## **DEPARTMENT OF PLANNING AND DEVELOPMENT**

### **STAFF REPORT**

APPL: Westchester Industrial Complex (Charles Cartalemi)  
3199 Albany Post Road, Suite 200 A  
Buchanan, NY 10511

RE: *January 13, 2026: The Planning Commission may declare itself the Lead Agency for the coordinated SEQRA review of the application for the proposed change in use and intensity of use from a single manufacturing occupancy to a multi-tenant mixed-use commercial facility with outdoor storage on properties located within the M-2B Design Industrial District. The Planning Commission will also provide a recommendation to the Common Council regarding Special Permits for outdoor storage pursuant to Sections 575-40.1 B and 575-40 B (1) of the City of Peekskill Zoning Ordinance.*

Aerial View: 1050 Lower South Street Sept 2025

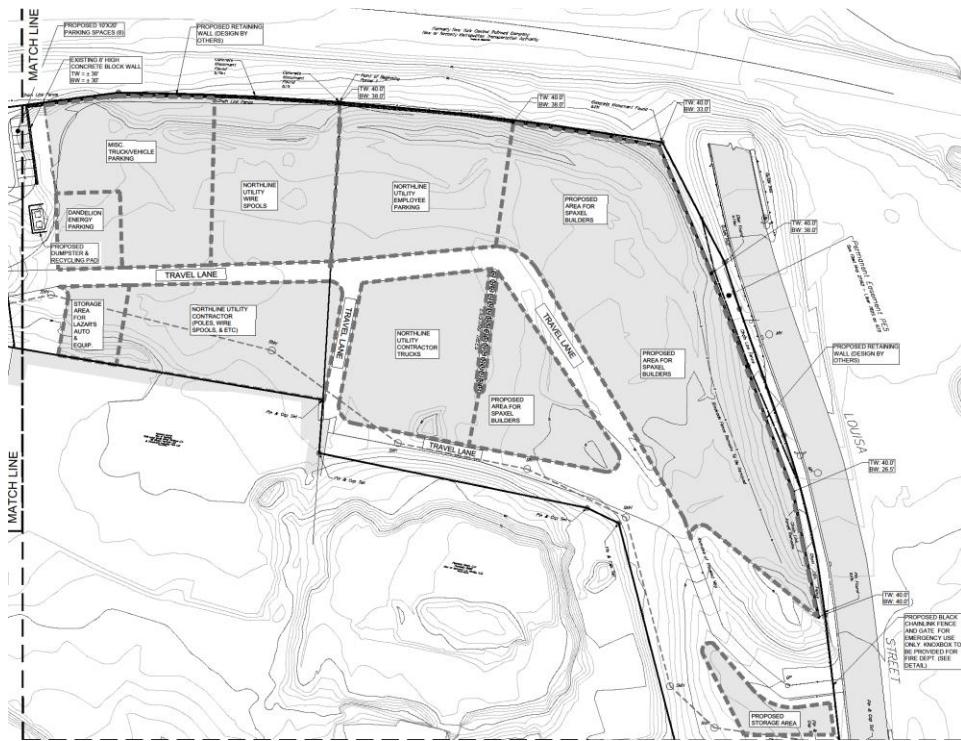
(2) The proposed use shall be of such location, size and character, and the nature and intensity of the operations involved in it or conducted in connection with it shall be such, that it will be in harmony with the appropriate and orderly development of the district in which it is proposed to be situated and will not be detrimental to the orderly development of adjacent properties in accordance with the zoning classification of such properties. *This Special Permit use (to park heavy vehicles and store equipment outdoors) can be considered in compliance with this objective since all adjacent properties contain similar uses on their sites (see adjacent land use info above). Only the subject building and car parking are visible from Lower South Street, and the special permit use is mostly screened from Louisa Street. Additional screening can be a condition of approval. The railroad tracks are at a much lower elevation, so the site is not visible from the train. Other industrial properties in M-2B are situated between Lower South Street and the subject property, so the truck parking and equipment storage is not visible (see aerial photo above).*
